# SERVICE BULLETIN

**NO. ARC 852-005** Rev. A

**Aircraft Restoration Corporation**

Bumper Brackett, P/N 85280119-00 interference with the rib doubler support angle at wing station 49.0.

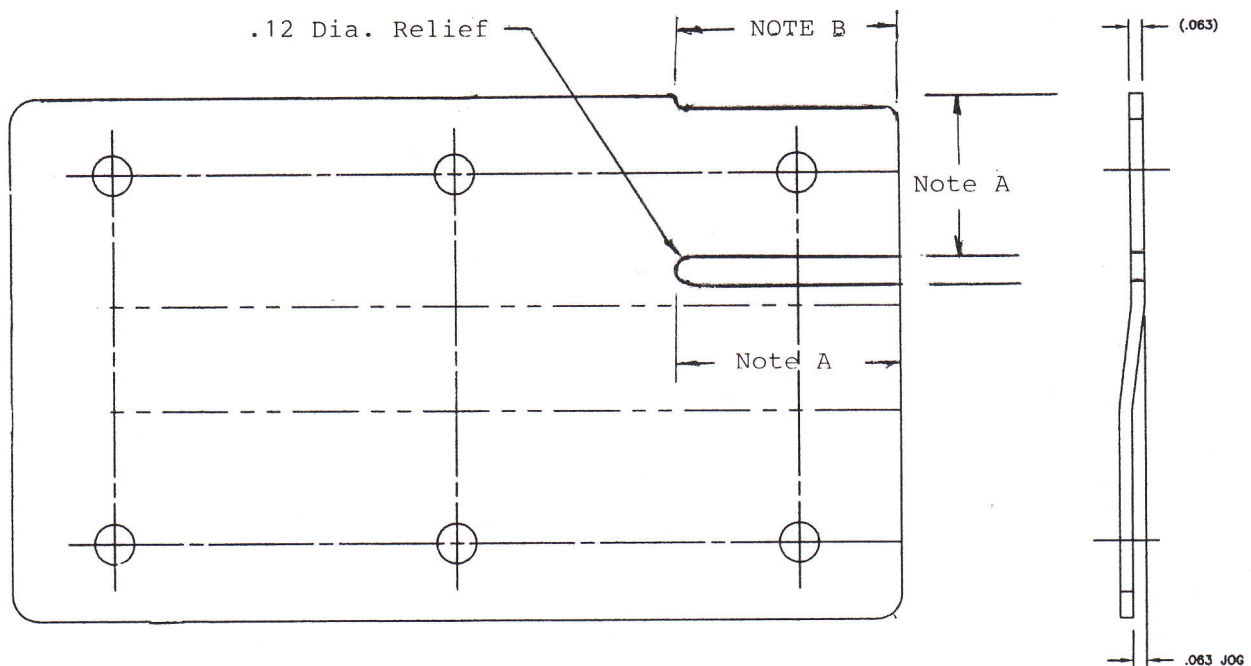
If your airplane has the rib doubler installed it will be necessary to complete this minor modification to provide needed clearance to allow the bumper extension bracket to be installed in accordance with the

Installation Procedures and the attached drawing. Position the bracket in its installed position, if the rib angle interferes cut a .12 notch in the bracket to eliminate the interference (NOTE A). Additionally, the top of the bracket might contact the same rib angle where it attaches to the wing skin (NOTE B). Remove as little material as possible to ensure a minimum of .02 clearance on all sides of the bracket.

**NOTE A:**

Final dimensions are determined at the time of installation, sufficient to maintain a minimum of .02 clearance.

**NOTE B:**

Remove material necessary to provide .20 clearance to the top of the rib angle and wing skin.
